# UNITED STATES PATENT AND TRADEMARK OFFICE

APPLICATION NO.	FILING DATE	FIRST NAMED INVENTOR	ATTORNEY DOCKET NO.	CONFIRMATION NO.
10/070,776	04/08/2002	Etienne Cousin	BDL-379XX	9662

# Office Action Summary

### **DETAILED ACTION**

Fig. 11.

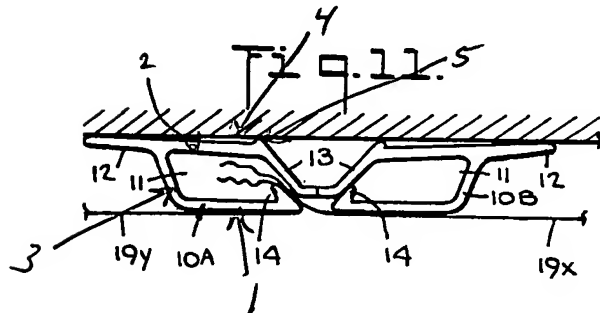
In regard to claim 1, Baslow discloses a rail section for stretched fabric partitions, said section comprising a groove 11 defined by an internal wing 1 (examiner's attachment), an external wing 2, and a base 3, an interval 4, i.e. the space between the rail and the wall, adjacent to the external wing and separating the external wing from a mounting surface, a joint including a lip 13, and a flap 5 outside the groove, said flap extending outward from said external wing toward said mounting surface, said lip being shaped and configured to pinch the fabric of the false partition between said lip and said internal wing, figure 11.
